HISTORIC LANDMARK COMMISSION STAFF REPORT

**Newhouse Apartments
New Construction
PLNHLC2012-00538
540 East 500 South
December 6, 2012**

Strategic Capital Group, represented by Adam Paul, requests approval to construct a multi-family structure at approximately 540 East 500 South. The demolition of the existing office building on the site was approved by staff on April 26, 2012.

OPT. 5
NORTH ELEVATION
 SCALE : 1/4" = 1'-0"

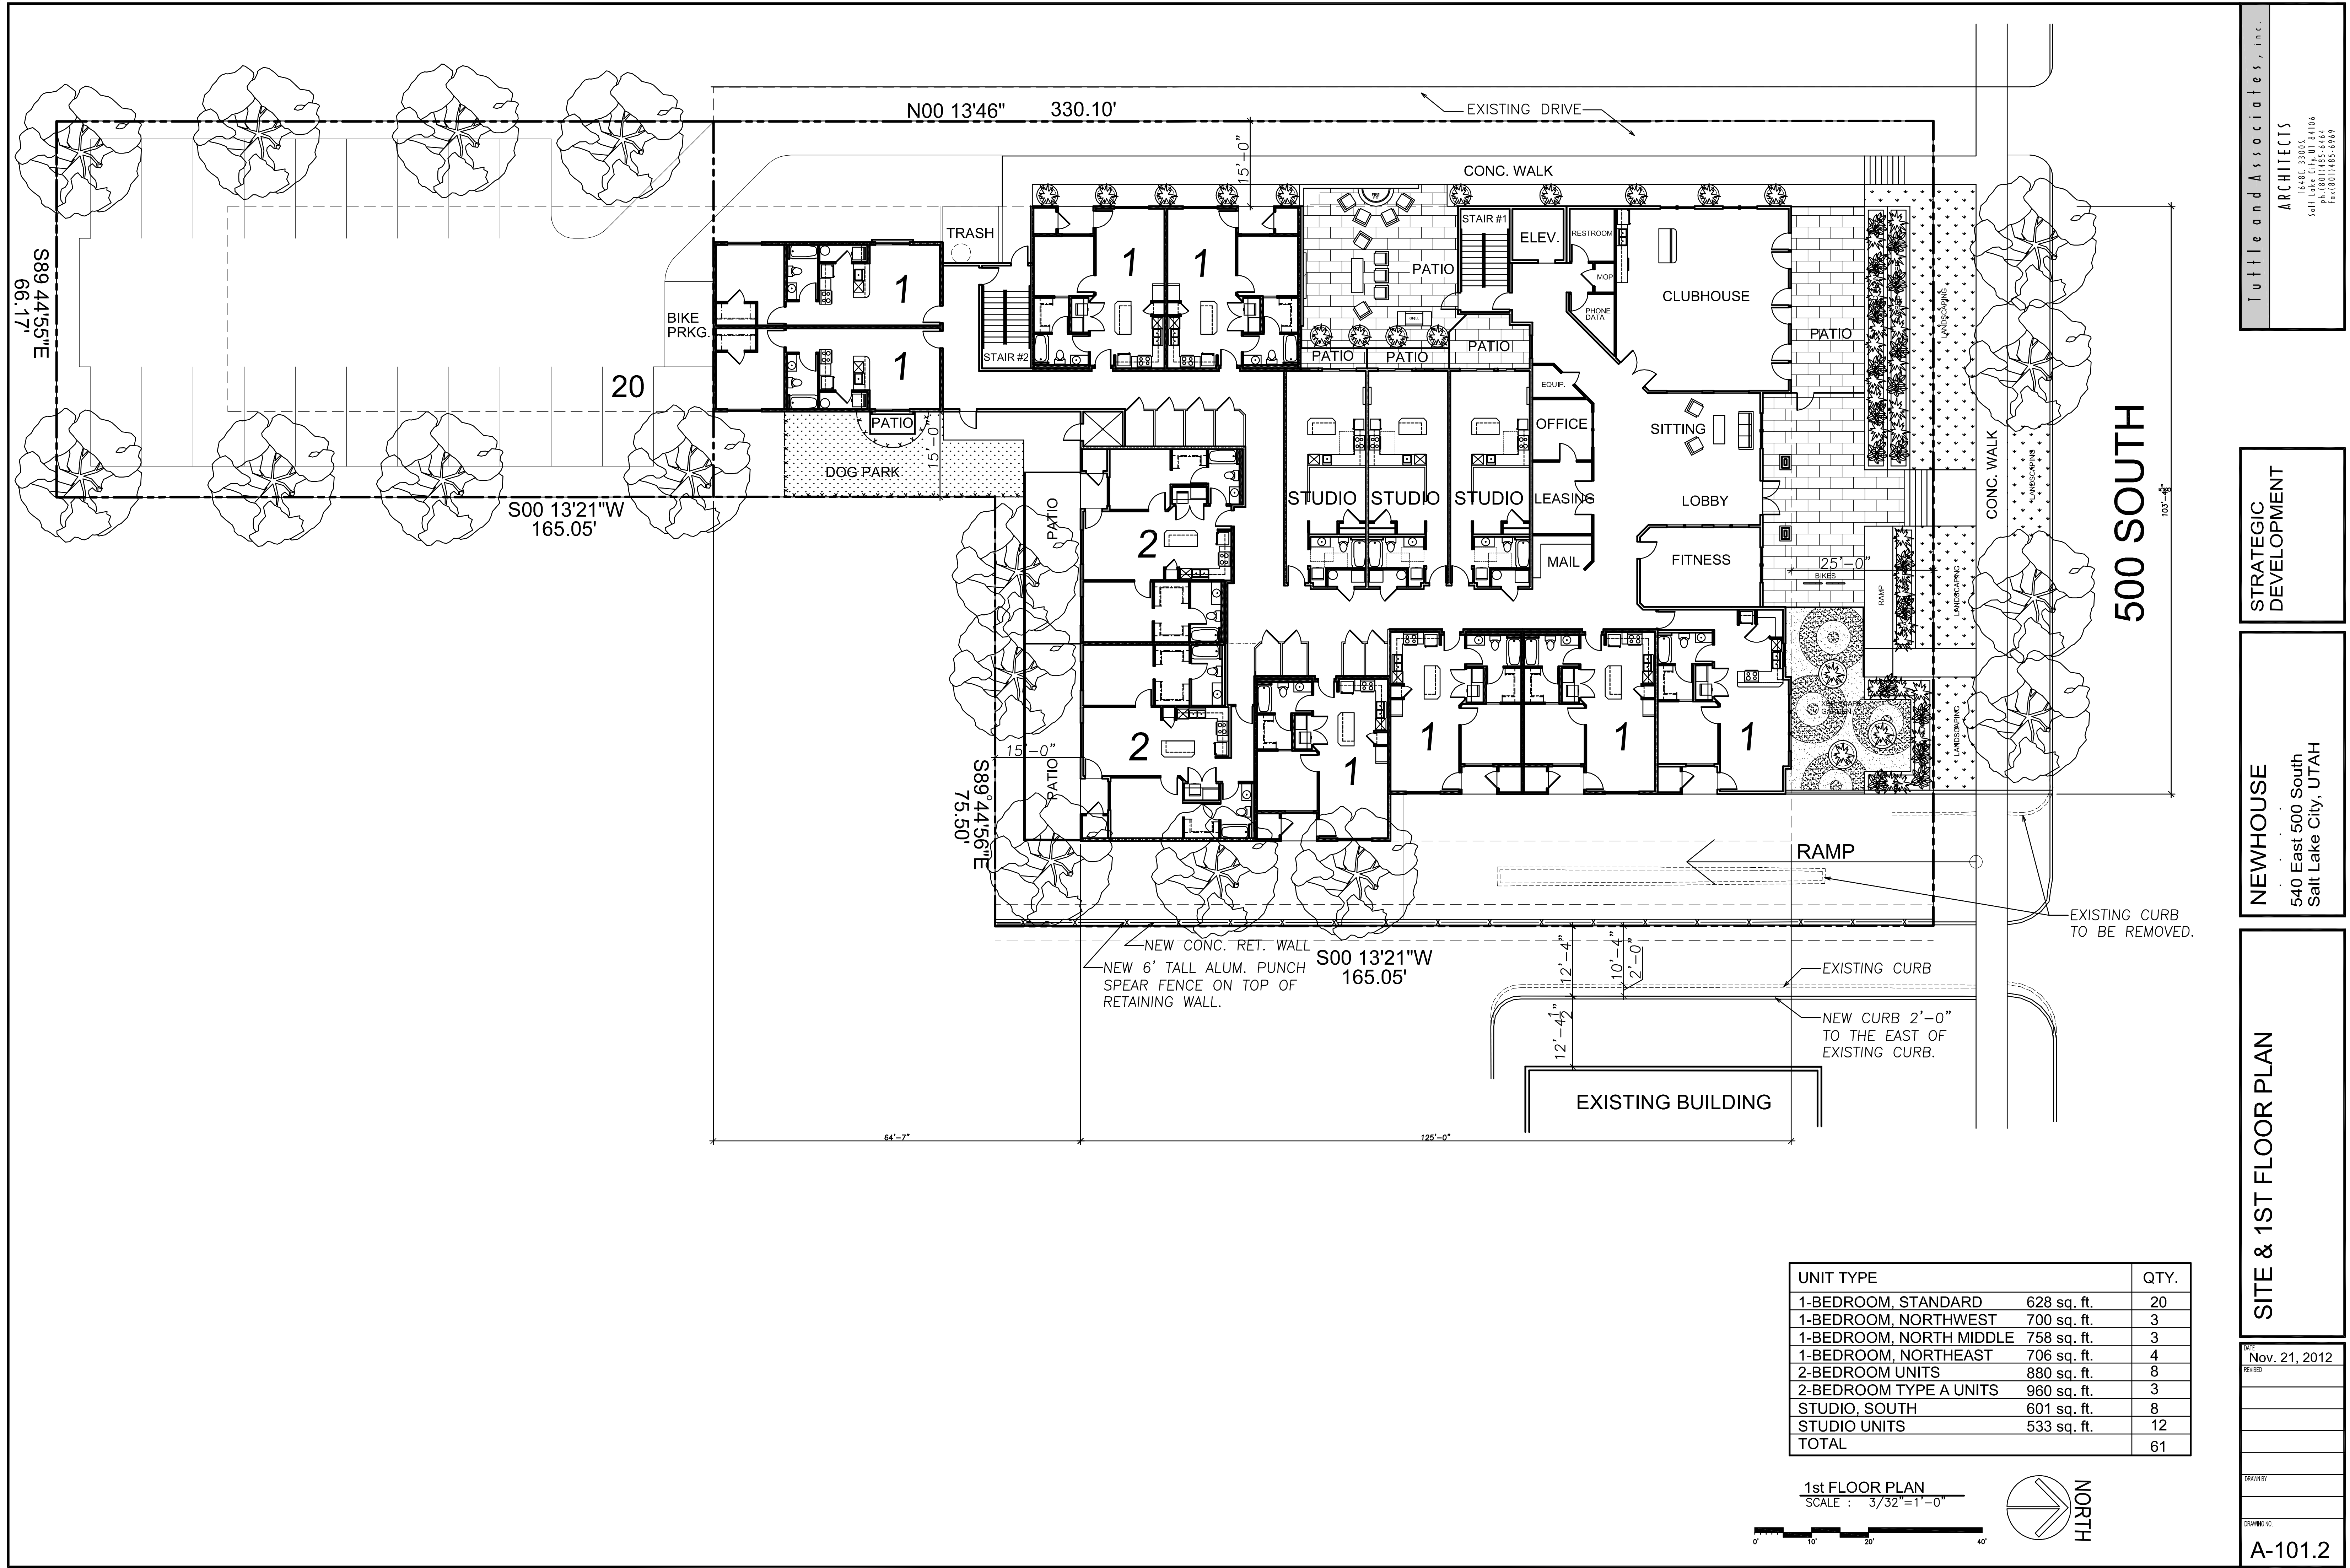
Analysis: The proposal is still taller than the surrounding buildings. It is now proposed to be forty-six feet (46’) tall. The block face averages thirty-two feet (32’) and the surrounding buildings are twenty-five feet (25’) (560 East 500 South) and nineteen feet (19’) (530 East 500 South). The applicant feels that the height of the building is not an issue but it was the initial massing that caused issues for the Historic Landmark Commission.

At the architectural subcommittee meetings, proposals with a stepped back fourth floor were presented. The step back has been removed in the proposal before the Commission for two main reasons according to the applicants. One, removing the step back will help reduce the construction costs of the building. The applicant is concerned about the financial feasibility of the project after reducing the size of the building to move it away from the homes on Hawthorne Avenue. Two, the applicant feels the step back did not provide enough of a benefit. Staff understands the financial concerns but feels that a step back would help alleviate the height difference between the proposed building and existing structures on the block face.

While the proposal is still much larger in size, mass and depth, the new design disguises the differences. The building’s elevations have been broken up with a pedestrian entrance on the front elevation, the parking garage entrance on the eastern façade and a common patio for residents on the western façade. The horizontal break of materials between a now traditional brick and Hardie panels gives the building a more horizontal look, similar to the surrounding buildings. The pedestrian entrance on the front elevation has been made more prominent. This helps the building achieve a more human scale.

Finding: The proposal generally meets this Standard, but a stepped back fourth floor would help address the issue of mass and scale.

Analysis: The proportion of openings and the rhythm of solids to voids will be compatible to the commercial buildings that surround the proposal. The emphasis of the pedestrian entrance on the front elevation is also visually compatible with the surrounding structures and helps increase the walkability of the project.

The mix of brick and Hardie panels are found on other buildings on the block. So the change of building materials helps the compatibility of the project. Brick is a traditional building material in the Central City Historic District. The larger Hardie panel is similar to another building on the block face, 510 South 600 East. Metal spacers are proposed to be used with the Hardie panel system to create a shadow effect.

Single-hung, vinyl windows are proposed. They will be recessed to be similar to traditional window treatments. The balconies will be constructed of perforated metal.

Analysis: The horizontal split of building materials helps the proposal fit into the rhythm of the block. The pedestrian entrance on the front elevation has become the dominant feature on the front façade with the parking garage entrance being moved off the front elevation.

SITE & 1ST FLOOR PLAN

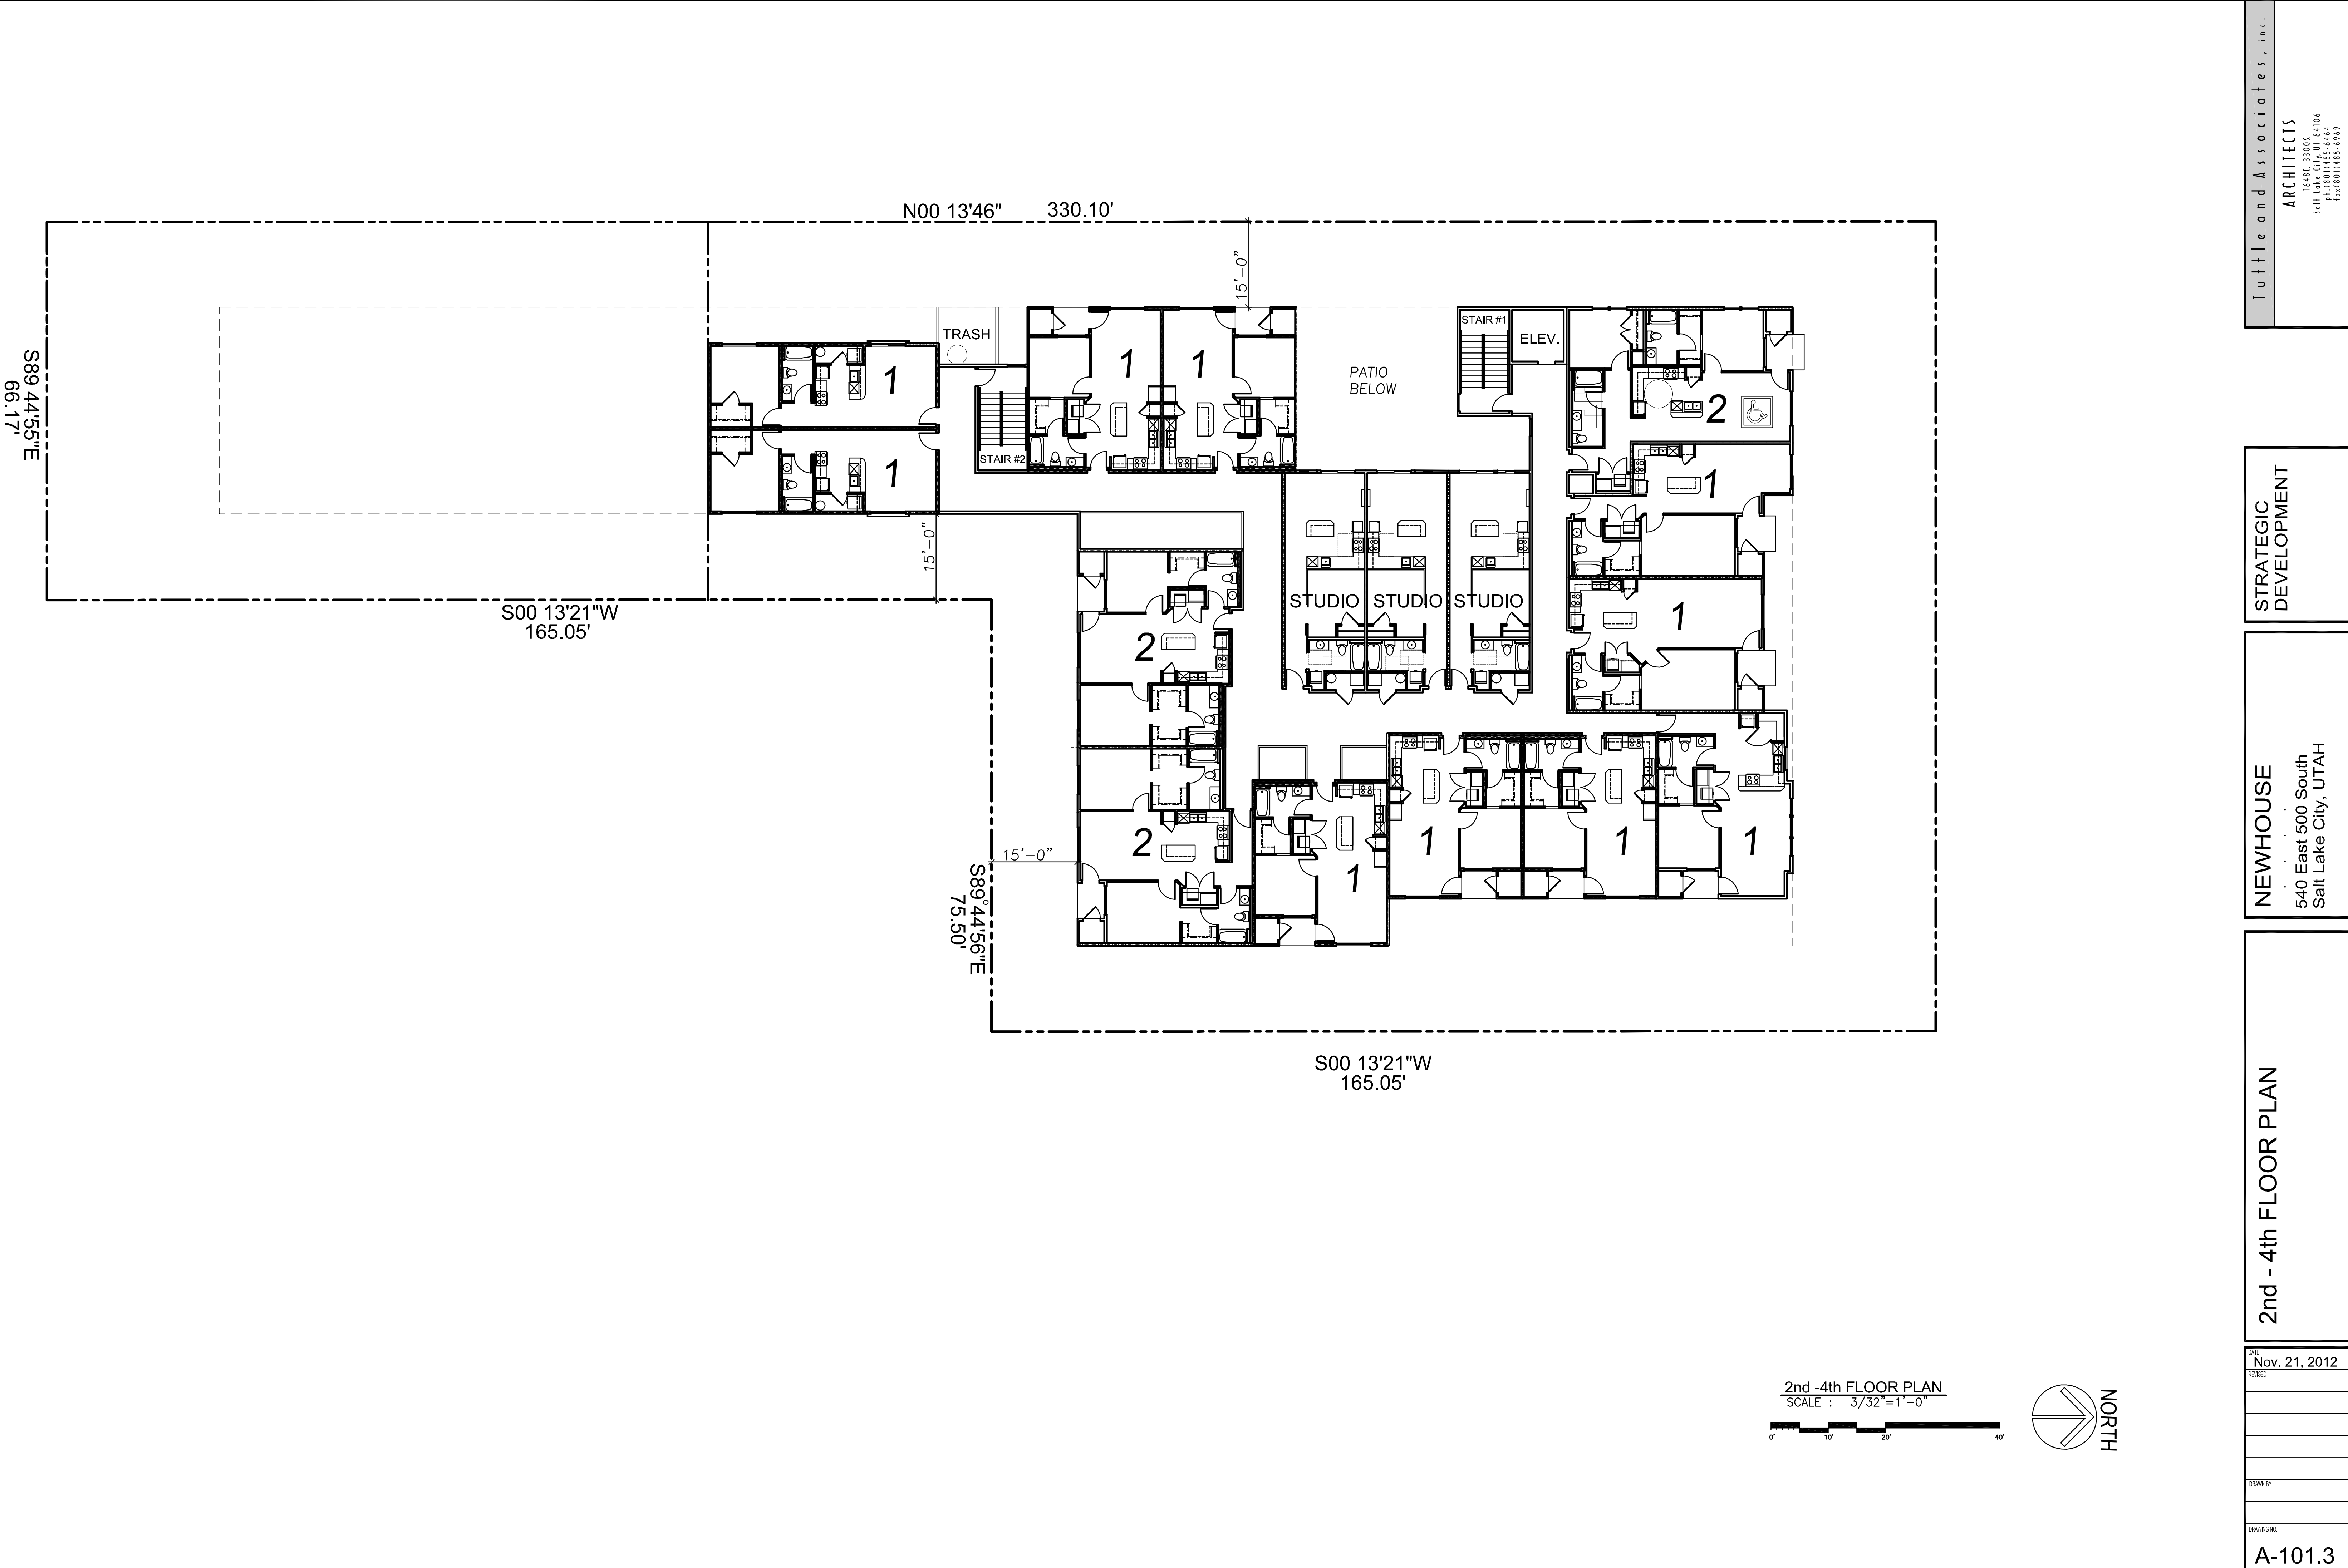
The other concern of the building’s proposed height was that it would only be thirty feet (30’) from the single family homes on Hawthorne Avenue to the rear. The building has now been pushed back to be one-hundred fifteen feet (115’) from the homes on Hawthorne Avenue. The rear of the proposed development will be a surface parking lot. This separation will provide a break for the height difference between the multi-story apartment building and single story homes on Hawthorne Avenue.

A surface parking lot now separates the proposed building from the single family homes on Hawthorne Avenue. Site lighting for this parking lot should be directed away from those homes. Staff asks that the Commission make a condition of approval that all site lighting is directed away from the homes on Hawthorne Avenue.

Finding: The proposal generally meets this Standard with the condition site lighting is directed away from the homes on Hawthorne Avenue.
